DART AEROSPACE LTD	Work Order:	101942
Description: Crosstube Assembly (205/212 High Aft)	Part Number:	D212-664-241
Inspection Dwg: D212-664-241 Rev: D		Page 1 of 2

DRAWING NO. D212-664-241	TITLE CROSSTUBE ASSY (205/212 HI AFT)	REV. D	DART AEROSPACE LTD ENGINEERING ORDER		D.E.O. NO. D212-664-241-D-1	SHEET NO. SHEET 1 OF 2	SCALE NTS
DRAWN	CHECKED	MFG. APPR.	APPROVED	DE APPR.			
DATE 11.04.07	DATE 11.04.11	DATE 11.04.12	DATE 11/04/12	DATE 11.04.12

DRAWING NO. D212-664-241	TITLE CROSSTUBE ASS'Y (205/212 HI AFT)	REV. D	DART AEROSPACE LTD ENGINEERING ORDER	D.E.O. NO. D212-664-241-D-2	SHEET NO. SHEET 1 OF 1	SCALE NTS
DRAWN <i>97</i>	CHECKED <i>ASS</i>	MFG. APPR. <i>DS</i>	APPROVED <i>MP</i>	DE APPR. <i>#</i>		
DATE 11.07.15	DATE 11.07.20	DATE 11.07.21	DATE 11/27/21	DATE 11.07.21

D212-664-241/-241B
ASSEMBLY DETAIL

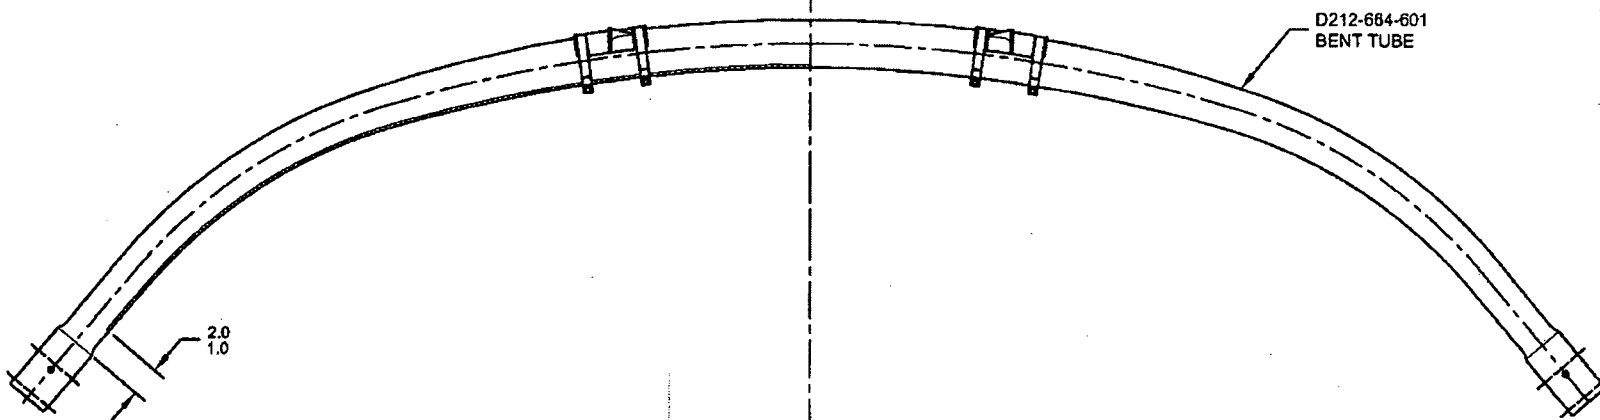
PURPOSE:

ADD AN INSPECTION WINDOW TO UNDERSIDE OF CROSSTUBE.

NOTES 2 OF SHEET 1 IS AMENDED AS FOLLOWS:

- 2) FINISH: CHEMICAL CONVERSION COAT PER DART QSI 005 4.1
PRIME INSIDE AND OUTSIDE PER DART QSI 005 4.2
MASK UNDERSIDE OF CROSSTUBE AS SHOWN (HATCHED AREA) AND
PAINT OUTSIDE PER DART QSI 005 4.2
REMOVE MASKING AND APPLY CLEAR COAT

MASK AREA PRIOR TO PAINTING,
REMOVE MASKING AFTER PAINT
AND APPLY CLEAR COAT
